### **Road Safety Audit Stage 1**

Transport Infrastructure Ireland  
**Galway City Transport Plan**  
Road Safety Audit – Stage 1

Issue 1 | 14 August 2017

Figure 2: Earthworks overlap – Bearna West Roundabout

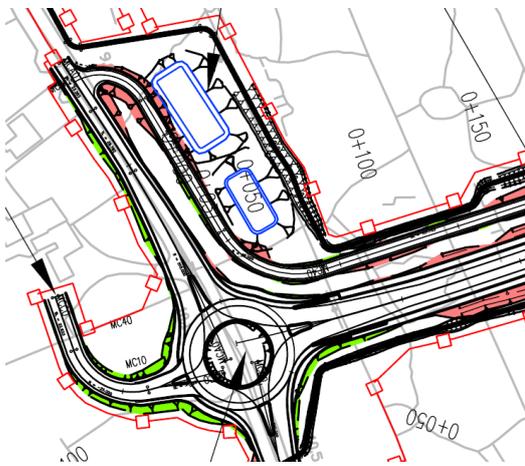
**Problem:** The earthworks design at various locations throughout the scheme appears to overlap (see figures 2 and 3). This could lead to an inability to construct the scheme as currently presented which could potentially result in a scheme which may be unsafe in parts for all users.

**Recommendation:** The Designer should reassess the earthworks design to ensure that the scheme can be constructed within the proposed scheme footprint without any adverse impact of all user's safety.

3.1	✓		✓		Areas of earthworks overlap have been re-examined to ensure that the scheme can be constructed. The scheme footprint takes account of construction requirements.	✓

Figure 4: Visibility to oncoming traffic

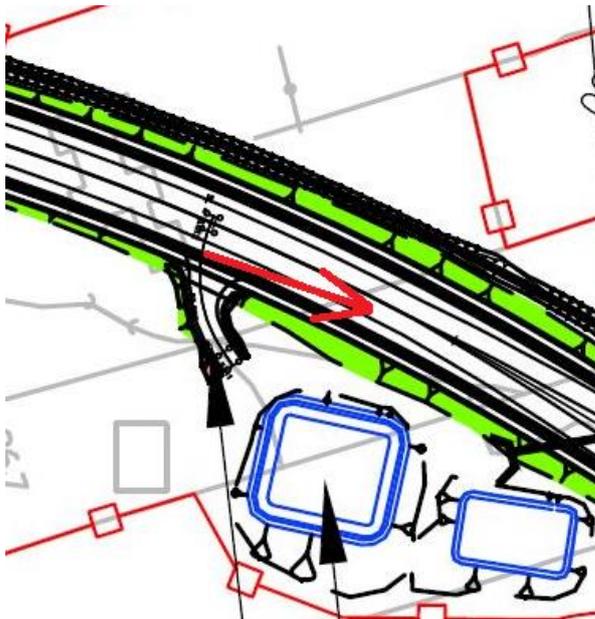
**Problem:** The Audit Team is concerned that there may be issues with appropriate sightlines at junctions being achieved as a result of proposed adjacent infrastructure. It is also noted that the level of detail provided to the Audit Team at this stage does not allow for an analysis of verge widening to ensure that visibility is achieved. Substandard visibility at junctions could increase the potential for collisions at these locations.

**Recommendation:** The Designer should ensure that they have allowed sufficient land take to provide the required visibility at all road junctions. The Designer should also demonstrate that sufficient visibility is provided by the preparation of the appropriate drawings.

3.2	✓		✓		Forward visibility has been provided in accordance with TII Publications. All junctions have been assessed to ensure visibility in accordance with TII Publications is provided.	✓

Figure 6: Attenuation pond with no access provided

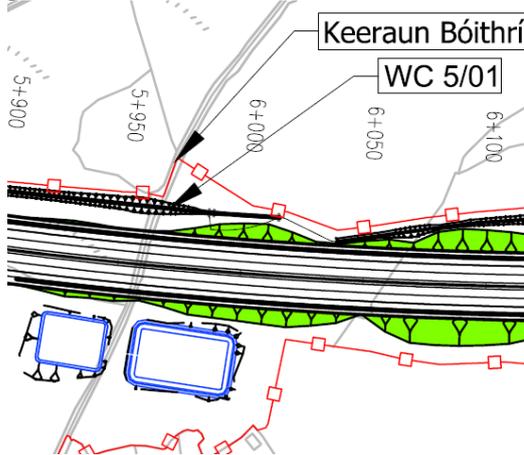
**Problem:** A number of attenuation ponds do not appear to have been provided with access roads or links to the adjacent road network (see figures 5 and 6). This could have an impact on the overall scheme design if the lands made available for the scheme are not extensive enough to cater for all design elements.

**Recommendation:** The Designer should ensure that all attenuation ponds are provided with an access either from the proposed scheme or the existing adjacent road network.

3.4	✓		✓		Access to all attenuation ponds has been designed within the lands made available for the scheme.	✓	
3.5	✓		✓		The clearance of Lackagh Tunnel and the Galway Racecourse tunnel have been increased to accord with TII Publications. Consequently, the exits now serve as	✓

Figure 8: Exit road at Lackagh Tunnel (eastbound)

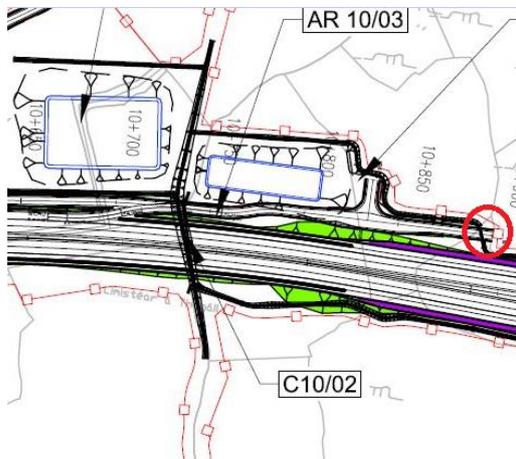
**Problem:** It is the Auditors' understanding that the exit roads on the mainline approaches to both tunnels are proposed in order to divert over height vehicles to the local road network to continue their journey. The Auditors are concerned that an over height vehicle that exits the mainline on the eastbound approach to Lackagh Tunnel (see figure 7) may have difficulty joining the local road network as there does not appear to be a turning area to enable the vehicle driver to do so. The Auditors are also concerned that an over height vehicle may need to reverse along the access road in order to join the local road network which could increase the potential for rear end shunt type collisions at this location.

**Recommendation:** The Designer should assess how an over height vehicle will reach the local road network having been directed from the mainline at this location. Measures should be put in place to make the required movements as simple as possible.

To be completed by the Designer				To be completed by Audit Team Leader	
Problem / Comment	Problem / Comment Accepted		Recommended Measure Accepted		Describe Alternative Measure	Alternative Measures Accepted	
	Yes	No	Yes	No		Yes	No
					<p>emergency exit routes. These emergency exit routes accommodate egress from the mainline during tunnel incidents. The operation of these emergency exits will be controlled by an intelligent transportation system.</p> <p>The emergency routes via which redirected vehicles will join the local road networks has been examined and simplified by eliminating the need to complete a turnaround.</p>

Figure 9: Sean Bothar diversion route

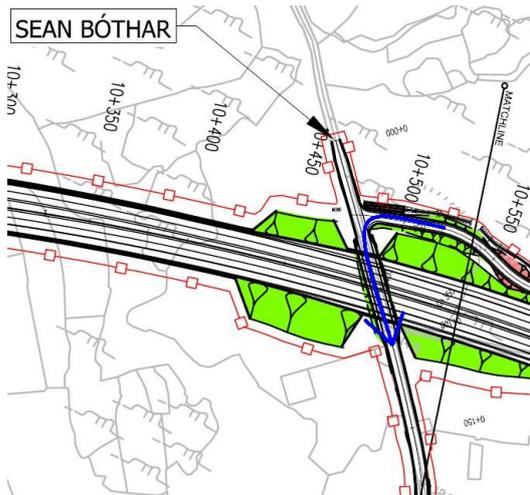
**Problem:** Exit roads are provided in advance of both tunnels in order to offer an alternative route to over height vehicles. The Auditors are concerned that some of the local road network may not be suitable for such vehicles (see figure 9) which could lead to blockages potentially resulting in various collision types.

**Recommendation:** Diversion routes should be developed from each exit road at the tunnels. These routes should indicate the maximum height available to such vehicles in order to minimise disruption to other road users.

3.6	✓		✓		<p>The clearance of Lackagh Tunnel and the Galway Racecourse tunnel have been increased to accord with TII Publications. Consequently, the exits now serve as emergency exit routes. These emergency exit routes accommodate egress from the mainline during tunnel incidents. The operation of these emergency exits will be controlled by an intelligent transportation system.</p> <p>The need for exiting vehicles to perform u-turn movements have been removed.</p> <p>The routes that overheight vehicles will utilise following departure from the mainline has been examined and where required are proposed for upgrade as part of the scheme so as to enhance safety and operational performance. Refer to drawings GCOB-100-DP-210 and GCOB-100-DP-217.</p>	✓

Figure 10: Lack of verge widening (Headford Road Junction)

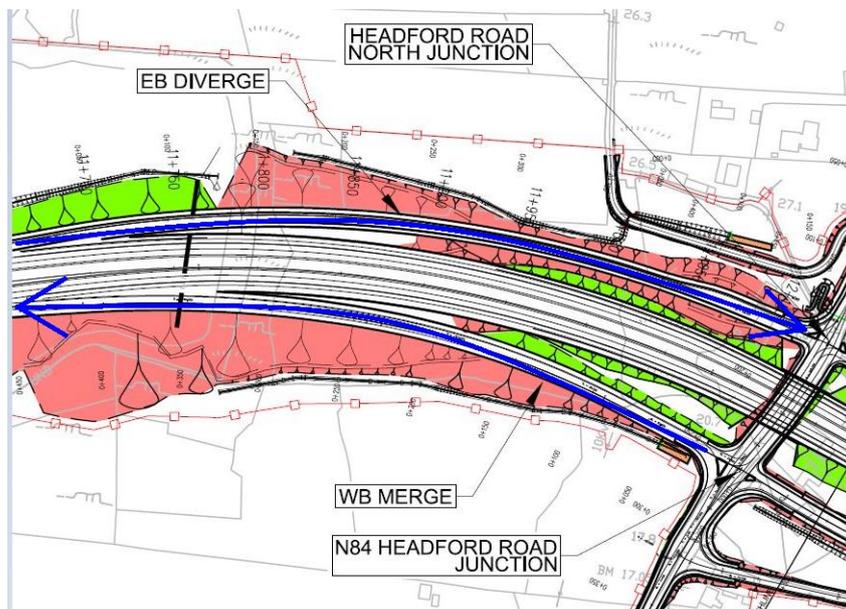
**Problem:** The Auditors are concerned that forward visibility on the eastbound diverges and westbound merges for these junctions may be insufficient as there does not appear to be verge widening proposed at this stage. Sub-standard forward visibility could lead to road users being unaware of a hazard within the carriageway ahead. This could lead to late braking or erratic manoeuvres potentially increasing the risk of collision at these locations.

**Recommendation:** The Designer should make an assessment of the requirements for verge widening and alter the design if necessary.

3.7	✓		✓		<p>Visibility for the Headford Road and N17 junction have been re-assessed. Visibility in accordance with TII Publications has been provided.</p>	✓

Figure 12: Lackagh Tunnel / N84 Headford Junction

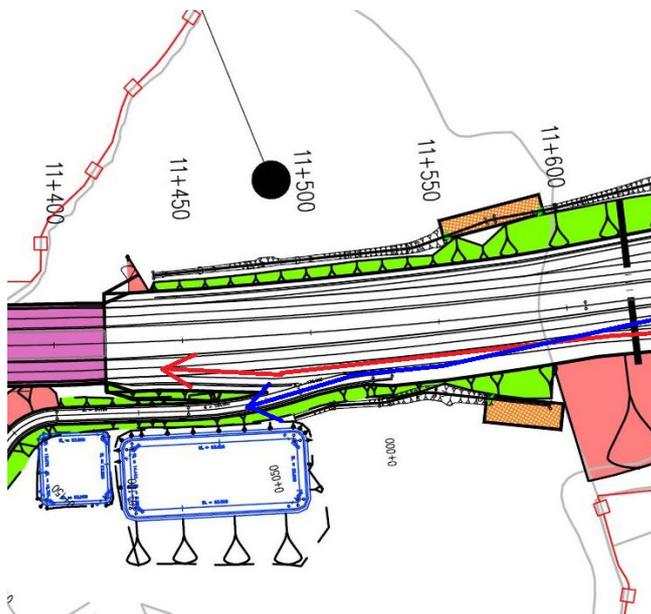
**Problem:** The Auditors are concerned about the proximity of this tunnel to the junction to the east. The diverge for the N84 begins almost immediately east of the tunnel and the merge from the N84 to the N6 terminates just east of the tunnel entrance.

Travelling eastbound there is little or no opportunity for the provision of the required advanced directional signage and the diverge commences immediately upon egress from the tunnel. This may lead to driver confusion potentially resulting in stopping or reversing on the mainline.

Travelling westbound the merge lane terminates at the tunnel entrance, where there is no hard shoulder. This could lead to slow moving vehicles attempting to merge into fast moving traffic which could potentially result in side swipe or rear end type collisions as well as increasing the risk of hard braking or skidding. The crossover between the over-height vehicle escape lane with the westbound merge lane exacerbates this situation by placing merging vehicles in direct conflict with egressing over-height vehicles. This additional conflict may result in additional issues for merging vehicles, particularly considering the potential restricted visibility afforded due to over-height vehicles exiting the carriageway.

**Recommendation:** The Designer should investigate widening the tunnel to include a hardshoulder or to extend the merge/diverge lanes through it. This would simplify the provision of signage on the eastbound direction and will reduce the potential for the collision types outlined.

Alternatively, the interchange could be relocated further east or the merge / diverge lane configurations adjusted to relocate their interaction points further east and away from the tunnel entrance / exit.

In relation to the emergency over height vehicle egress, egressing vehicles should not be in direct conflict with merging vehicles. The Designer should take this into account in the redesign of the egress for these vehicles.

3.9	✓			✓	<p>The interaction of the N84 and Lackagh Tunnel portal has been examined and the following measures are proposed to enhance safety and operational performance.</p> <p>Travelling eastbound the length of the auxiliary lane of the parallel diverge has been reduced to 100m to provide a travel distance between the Lackagh portal and the start of the diverge taper thereby allowing diverging traffic to identify the diverge. Hourly diverging traffic flows for the 2039 design year, with high growth, are low (169) thereby minimising the interaction between diverging and mainline traffic. A departure from standard has been obtained from TII for the reduced auxiliary lane length. The area will be lit to enhance the safety of the scheme and ensure the layout is clearly visible to road users. The diverge will be appropriately sign posted via fixed signage (posts and gantries) allowing motorists to anticipate the diverge.</p> <p>Travelling westbound the hourly merging traffic flows for the 2039 design year, with high growth, are low (242) thereby minimising the interaction between merging and mainline traffic. The area will be lit to enhance the safety of the scheme</p>	✓

To be completed by the Designer				To be completed by Audit Team Leader	
Problem / Comment	Problem / Comment Accepted		Recommended Measure Accepted		Describe Alternative Measure	Alternative Measures Accepted	
	Yes	No	Yes	No		Yes	No
					<p>and ensure the layout is clearly visible to road users. The merge will be appropriately sign posted via fixed signage (posts and gantries) allowing motorists to anticipate the diverge.</p> <p>Regarding the emergency route which is in proximity to the Lackagh tunnel portal and the N84 westbound diverge. The clearance of Lackagh Tunnel and the Galway Racecourse tunnel have been increased to accord with TII Publications. Consequently, the exits now serve as emergency exit routes. These emergency exit routes accommodate egress from the mainline during tunnel incidents. The operation of these emergency exits will be controlled by an intelligent transportation system. Thus vehicular traffic interactions at this location will be limited to tunnel incidents and not everyday usage.</p> <p>Refer to drawing GCOB-100-DP-108.</p>
